Proposal Request

P.R. No.: **002**
Project No.: 15-0409.001
Project: **New Intermediate School**
Date: 5/10/17

NEW INTERMEDIATE SCHOOL

DRAWING NAME
**WALL SECTION -
DOOR
ELEVATIONS/DETAIL**

1 WALL SECTION: REF 1/A101A
1/2" = 1'-0"

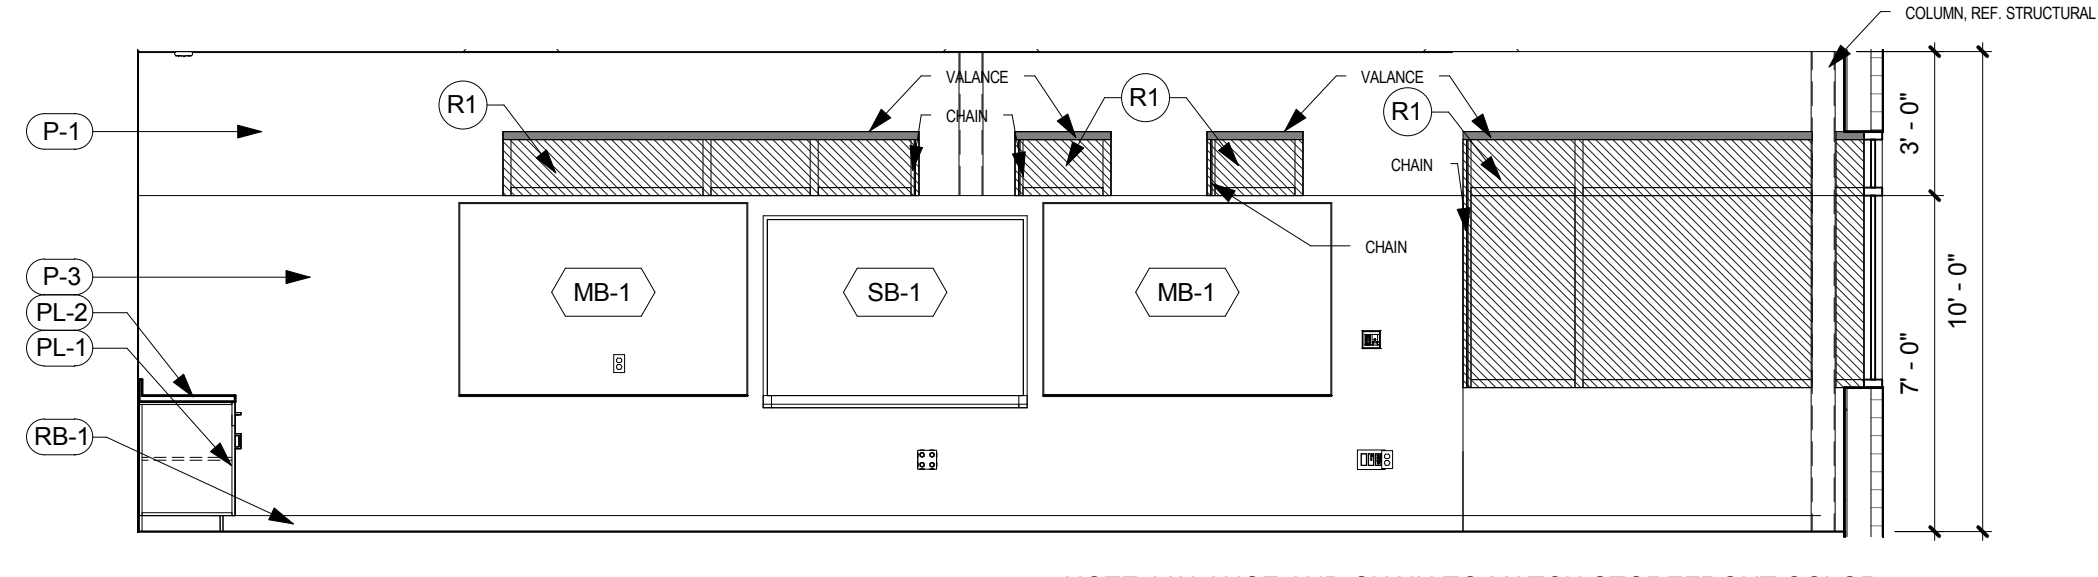
13. Specification Section 10100 A. Provide “Claridge 119 Mounted Corkboard, (Claridge Cork)” in lieu of “Claridge 1550 with vinyl wall covering”.
14. Replace detail 1 on Sheet A101A with the revised section on the attached Sheet. Provide credit to owner.

- a. This detail shows that the gyp. board furr down over the roller shades in the classrooms over the smart boards/teaching wall has been removed and now the lay in ceiling extends to the exterior wall. The roller shades shall be within the window opening with a concealment valance for the windows over the smart boards and the corner storefront in the classrooms, reference interior elevation number 4 on the attached sheet.

2 DOOR TYPES
1/4" = 1'-0"

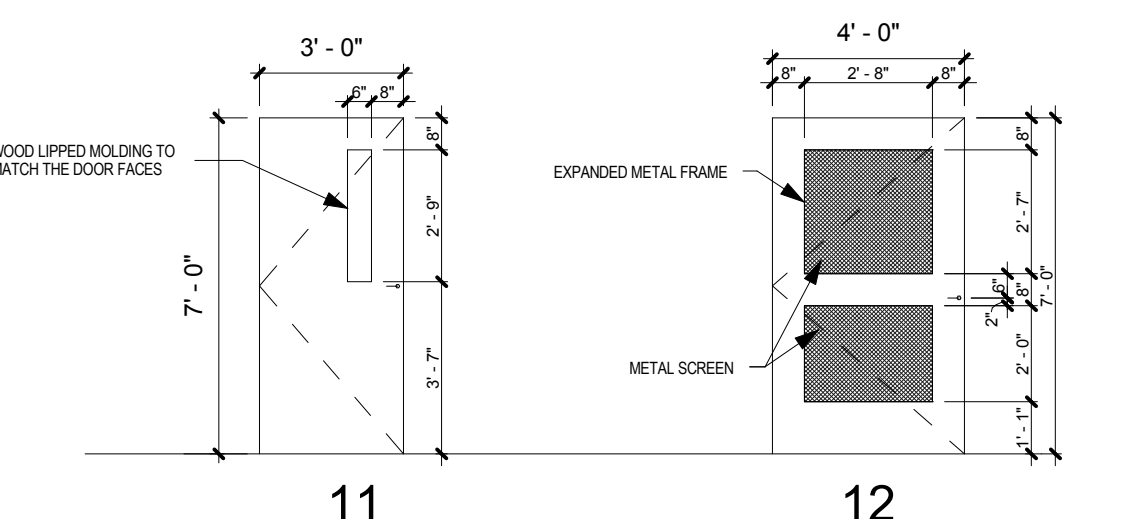
1. **Remove** Door Frame D (Hollow Metal with ¼” Tempered Glazing Side Lite) with Door Type 1 (Solid Wood Core) and **replace** with Door Frame A (Welded Hollow Metal) with added Door Type 11 shown attached (Solid Wood Core with Lite) for all door locations excluding doors 168B and 170. Provide credit to owner.

2. **Clarify** Conference Rooms (181 and 176) are to have added door type 11.
3. **Clarify** door 137 is door type 7.
4. Replace any mention of the term “Science Lab” with the term “Science Classroom”

11. Remove air curtain over door 114J and provide a screen door at this location, reference door type 12 on the attached sheet.
12. At all wall locations that are to receive tile, substitute the ½” Cement Board and 5/8” gyp. wall board above with National Gypsum eXP Interior Extreme AR Gypsum Panel.
